HISTORIC AND DESIGN REVIEW COMMISSION

HDRC CASE NO: 2022-404
ADDRESS: 220 LEIGH ST
LEGAL DESCRIPTION: NCB 723 BLK 5 LOT 10
ZONING: RM-5, H
CITY COUNCIL DIST.: 1
DISTRICT: Lavaca Historic District
APPLICANT: Nathan Manfred/French & Michigan
OWNER: Michael Glatter/GLATTER MICHAEL R
TYPE OF WORK: Demolition of rear accessory structure and new construction of a 2-story rear accessory structure
APPLICATION RECEIVED: May 12, 2023
60-DAY REVIEW: July 11, 2023
CASE MANAGER: Rachel Rettaliata

The applicant is requesting a Certificate of Appropriateness for approval to:

1. Demolish the existing 1-story rear accessory structure.
2. Construct a new 2-story rear accessory structure.

2 220 LEIGH ST - EAST ELEVATION
SCALE: 1/4" = 1'-0"

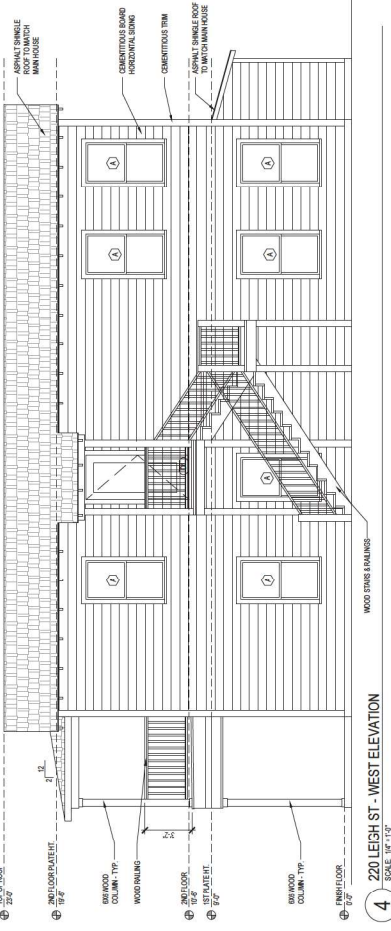
- 2g. RELATIONSHIP OF SOLIDS TO VOIDS – Guideline 2.C.i for New Construction stipulates that new construction should incorporate window and door openings with a similar proportion of wall to window space as typical with nearby historic facades. Windows, doors, porches, entryways, dormers, bays, and pediments shall be considered similar if they are no larger than 25% in size and vary no more than 10% in height to width ratio from adjacent historic facades. Guideline 5.A.iv for New Construction states that window and door openings should be designed to be similar to those found on historic garages or outbuildings in the district or on the principle historic structure in terms of their spacing and proportions. The applicant has submitted elevation drawings that feature windows with traditional window proportions as well as narrow horizontal fixed windows on the east elevation. Staff finds that the applicant should proposed a fenestration pattern with traditional proportions and traditional operations.

- i. That the applicant submits porch column details to staff prior to the issuance of a Certificate of Appropriateness showing that the wood columns will be a maximum of 6x6" in width and feature a traditional cap and base and chamfered corners based on finding 2e.
- ii. That the applicant proposes a fenestration pattern and window opening proportions that are more consistent with the Guidelines as noted in finding 2g. The applicant is required to submit updated elevation drawings showing

traditional window proportions on the east elevation to staff for review prior to the issuance of a Certificate of Appropriateness.
